A63 Castle Street Improvement, Hull

DCO Documents Errata

- 1.1.1 This Errata lists amendments to the Development Consent Order (DCO) documents which formed the A63 Castle Street Improvement, Hull application submitted to the Planning Inspectorate in September 2018. The Errata focuses upon corrections as opposed to typographical errors. Documents are presented in the order with which they were submitted for DCO.

5.1.1 Replace ES Volume 2 Figure 15.2 Proposed non-motorised users facilities and closure for the Scheme (APP-040) with the revised Figure 15.2 as below. Changes are as follows:

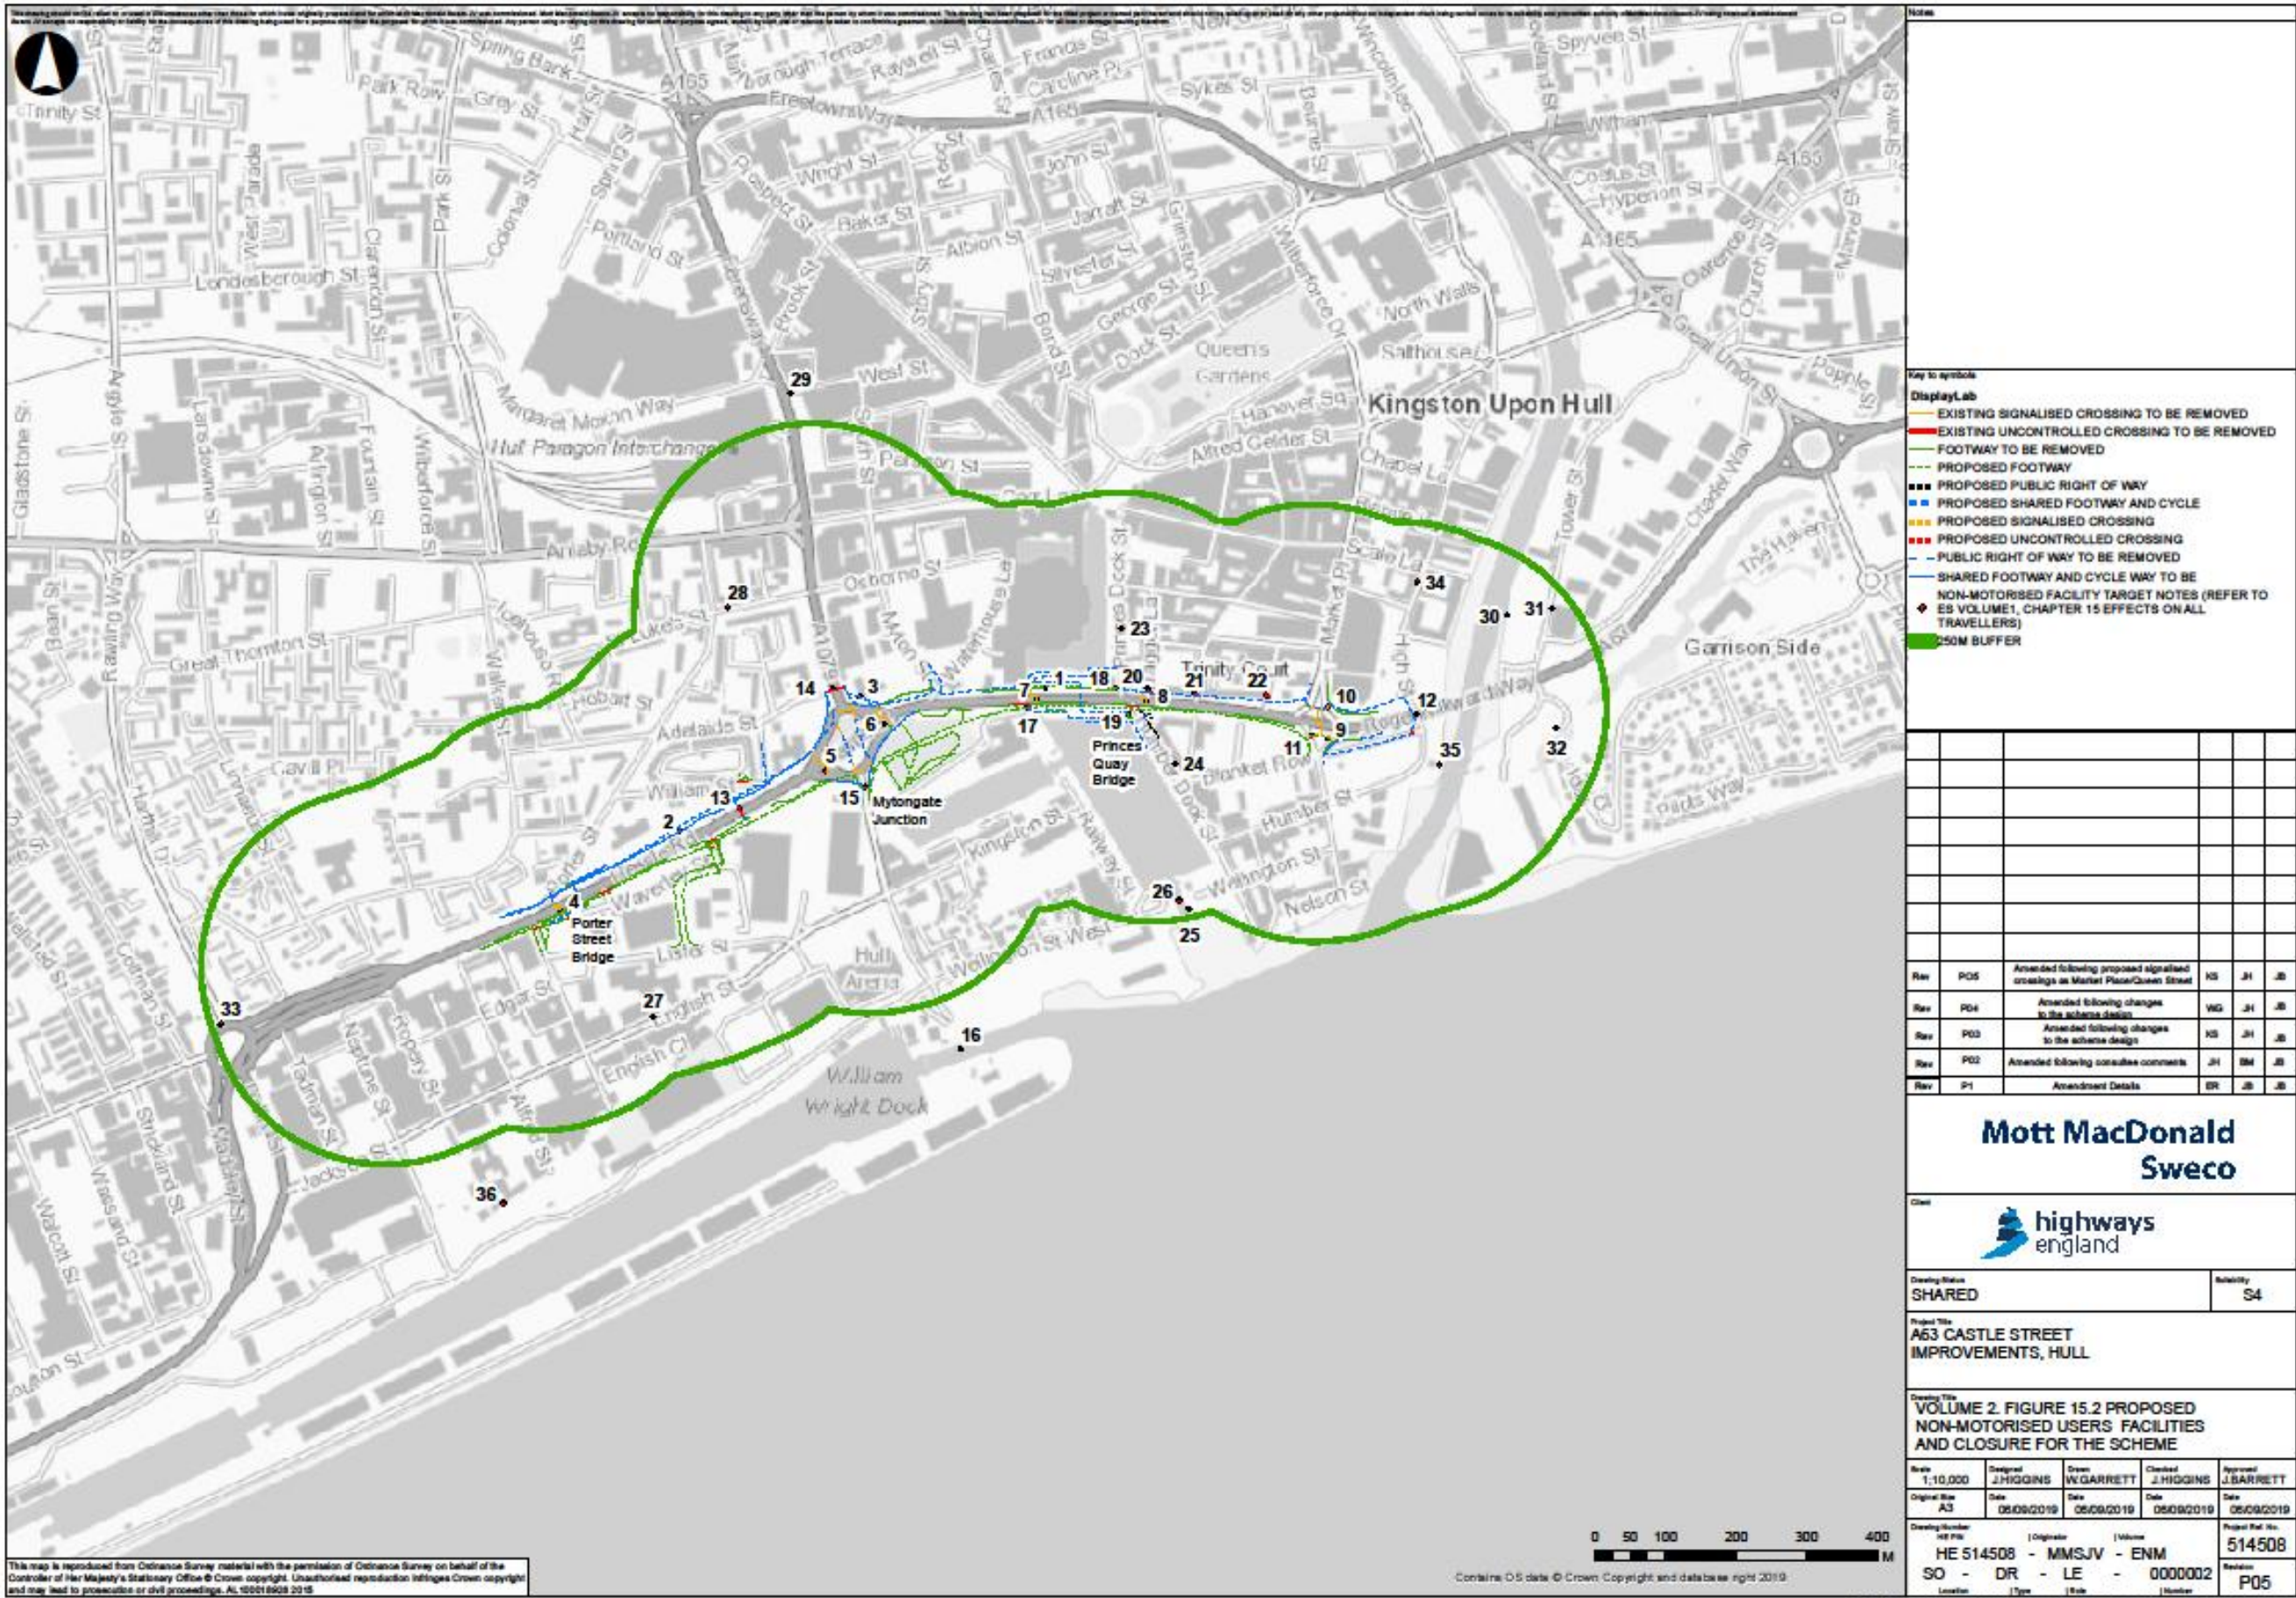
- Locations of the combined footpath & cycleway have been clarified.
- Signalised crossings at Market Place and Queen Street are to be retained.
